Lower Thames Crossing

9.152 Responses to the Examining Authority's ExQ2 Appendix G – 11. Biodiversity (Part 1 of 2)

DATE: October 2023
DEADLINE: 6

Planning Inspectorate Scheme Ref: TR010032
Examination Document Ref: TR010032/EXAM/9.152

ExQ2_Q11.3.2 figures: Figure 2 - Open Mosaic habitat loss mitigation

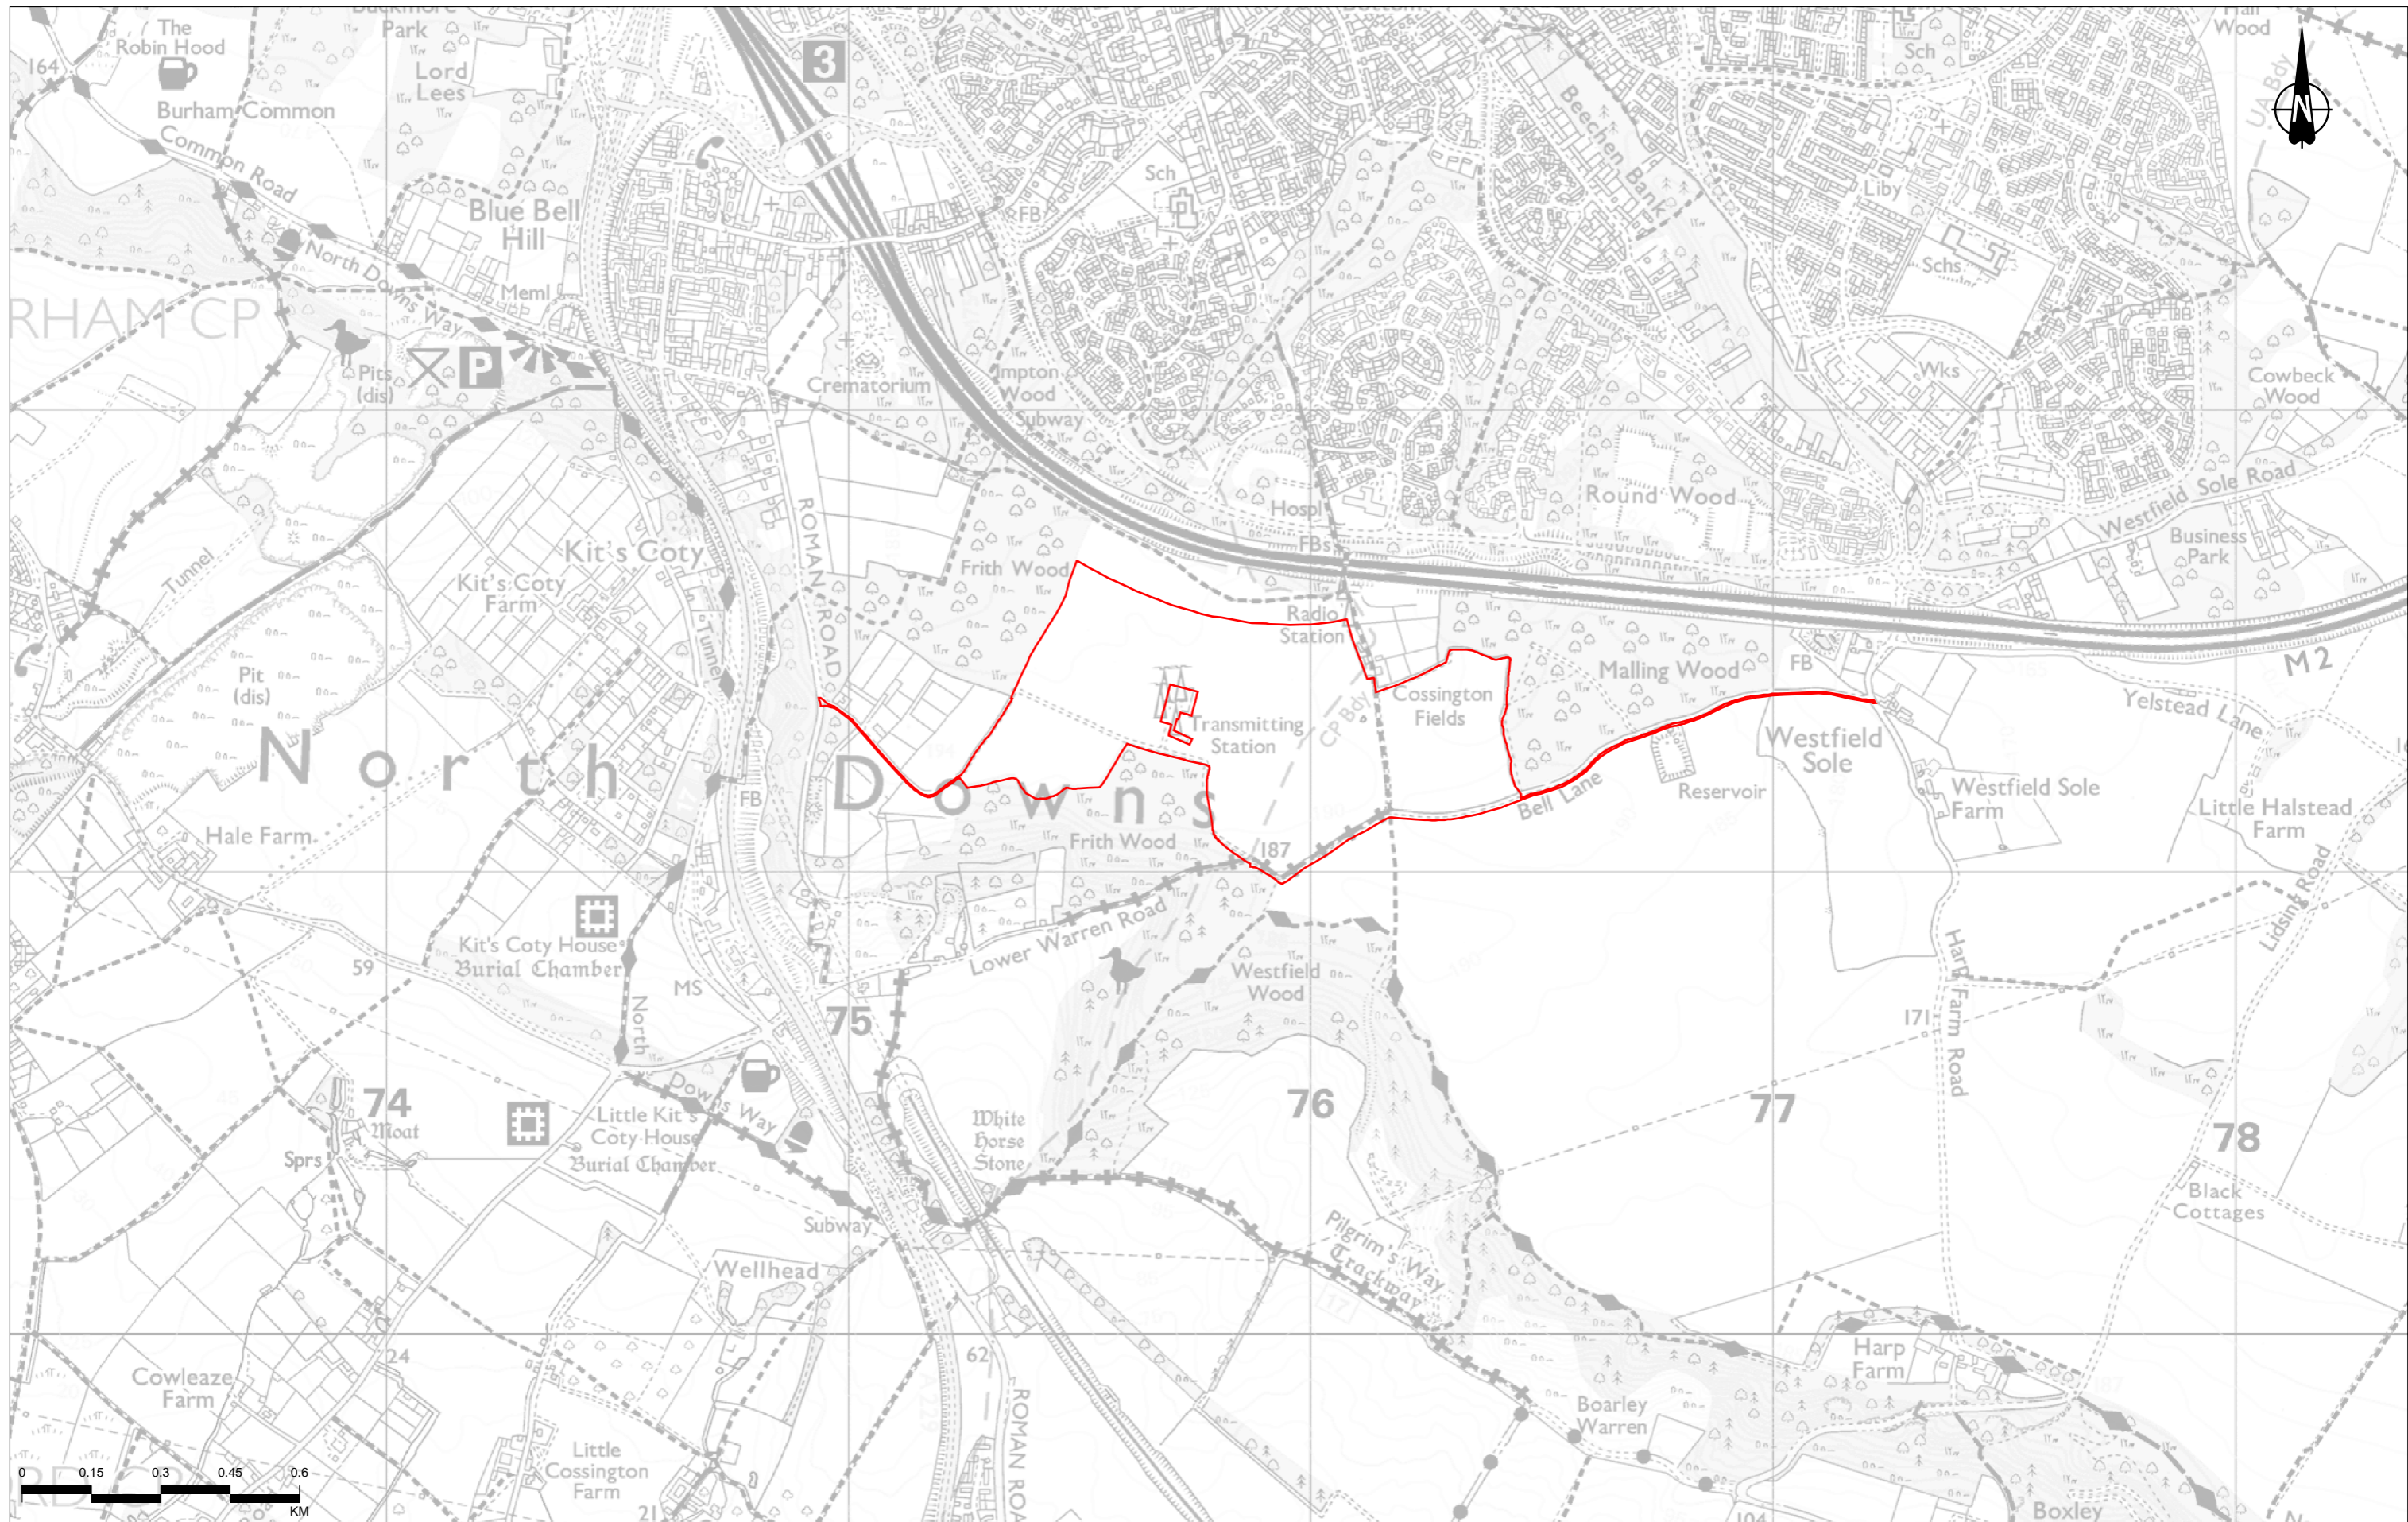
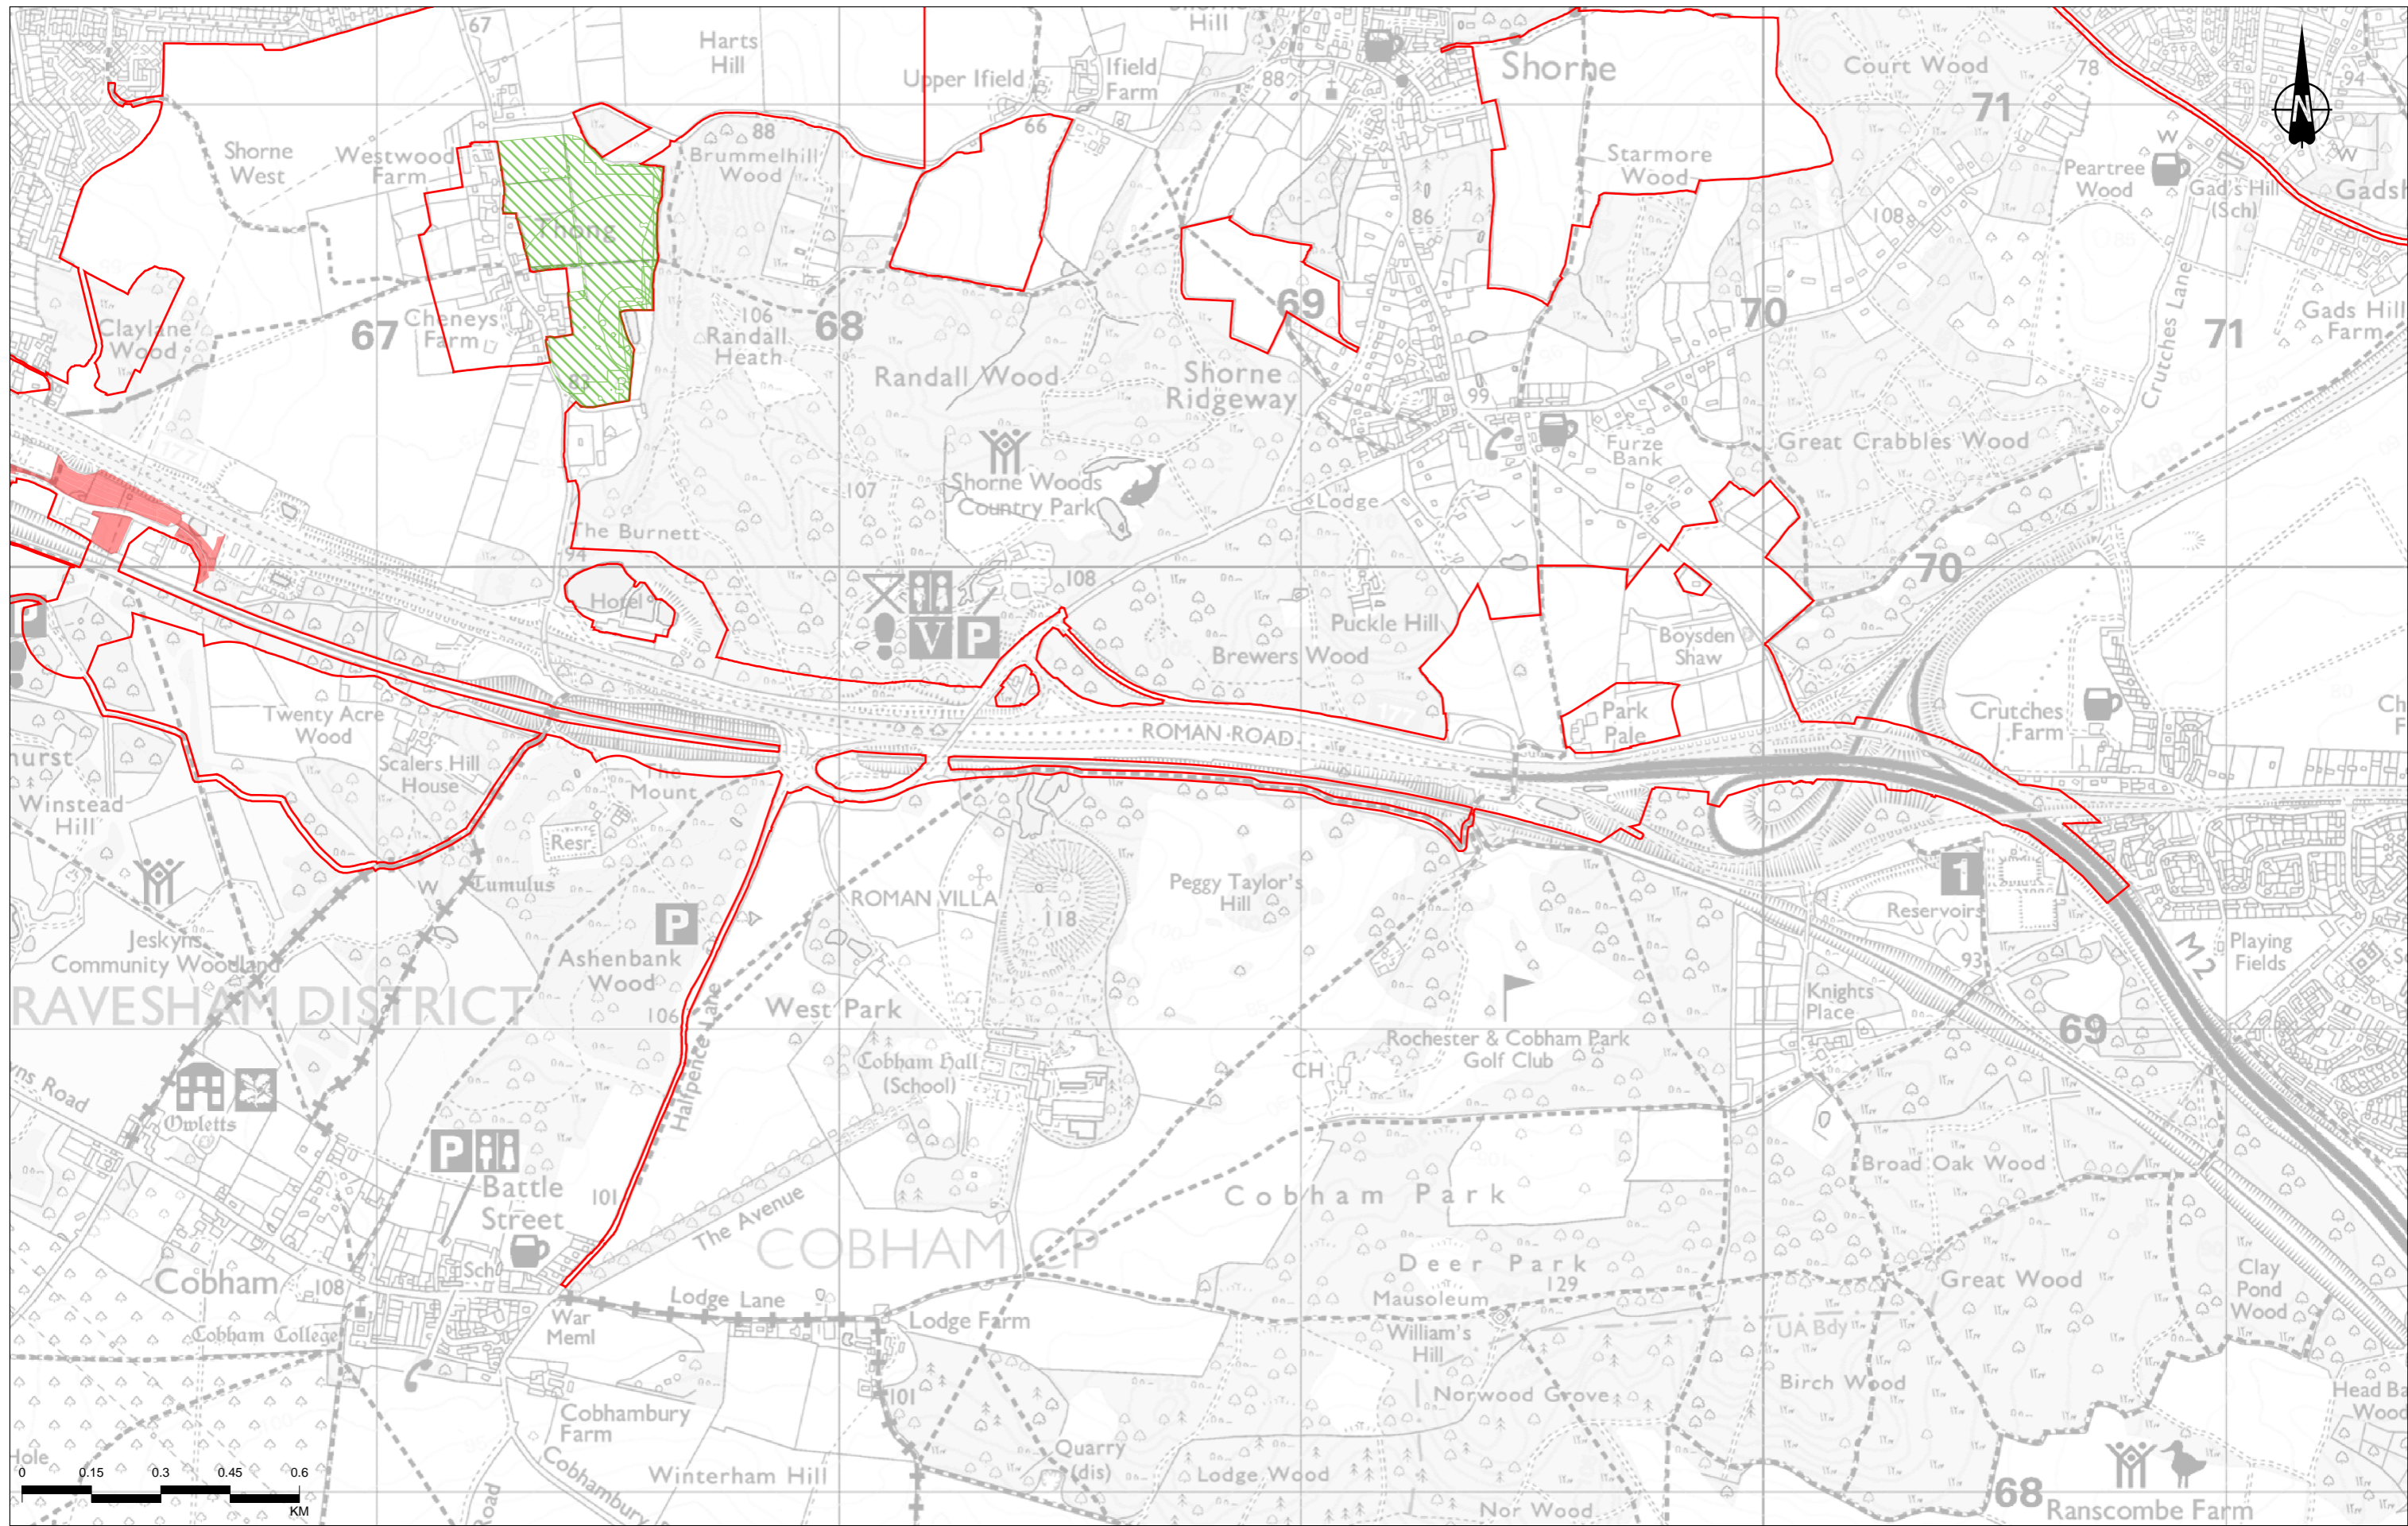
ExQ2_Q11.3.2	Applicant	<p>Offsetting</p> <p>The document reference 9.90 Mitigation Route Map [REP4-203] is noted, but the ExA would like to see a simple graphical representation / location plan to understand which area(s) of habitat are being created for particular impacts; such an approach will help provide clarity that the impacts are fully mitigated or compensated for. The detail provided in Tables 8.31 (south of the River Thames) and 8.35 (north of the River Thames) of Chapter 8 Terrestrial Biodiversity of the Environmental Statement [APP-146] are noted, but it continues to be difficult to track where the individual areas of habitat impacted are mitigated or compensated for on the ground within the submitted documents.</p> <p>Response:</p> <p>The Applicant has provided simple graphical representations which illustrate the location and extent of habitat creation proposals and the corresponding Project impacts for which they provide mitigation and compensation. These cover the following key habitat types:</p>

PINS ID	Question to:	Question / Response
		<ul style="list-style-type: none"> • Woodland (excluding designated woodland loss and compensation which is reported in ES – Figure 8.33: Ancient Woodland Impacts [APP-294]) • Open mosaic habitat • Grassland (excluding amenity and poor semi-improved grassland of low biodiversity value) • Hedgerows <p>These figures are provided in the Figures Annex to this document. We are also working to produce a similar map showing wetland habitats which, due to the range of wetland habitats involved, will be submitted at Deadline 7.</p>
ExQ2_Q11.3.3	Applicant	<p>Biodiversity Net Gain (BNG)</p> <p>In a similar manner to ExQ2 Q11.3.2 of this set of questions, the ExA requests the Applicant provide a graphical representation / location plan in addition to that detailed above showing all areas of environmental improvement included in the BNG metric.</p> <p>Response:</p> <p>The Applicant’s BNG Metric assessment [APP-417] includes all areas of <i>direct habitat loss and creation</i> within the Order Limits, with the following exceptions:</p> <ul style="list-style-type: none"> • Ancient woodland habitat lost (6.87ha) as a result of the Project is excluded from the baseline assessment. • Wood-pasture parkland habitat lost (0.07ha) as a result of the Project is excluded from the baseline assessment. • Bespoke compensation for ancient woodland loss (81ha) is excluded from the post-intervention assessment. • Nitrogen deposition compensation areas (246ha) are excluded from both the baseline and post-intervention parts of the assessment. <p>Areas of temporary land-take within the Order Limits are included in the BNG Metric assessment. For these areas, there is an assumption in the Metric assessment that the baseline habitat is lost and then re-instated post-construction to the same habitat type and condition as in the baseline.</p> <p>These explanatory notes support the Applicant’s submission of graphical representations / location plans which the Applicant commits to issuing by Deadline 7, so that it is clear which features on the plans are included in the BNG Metric.</p>
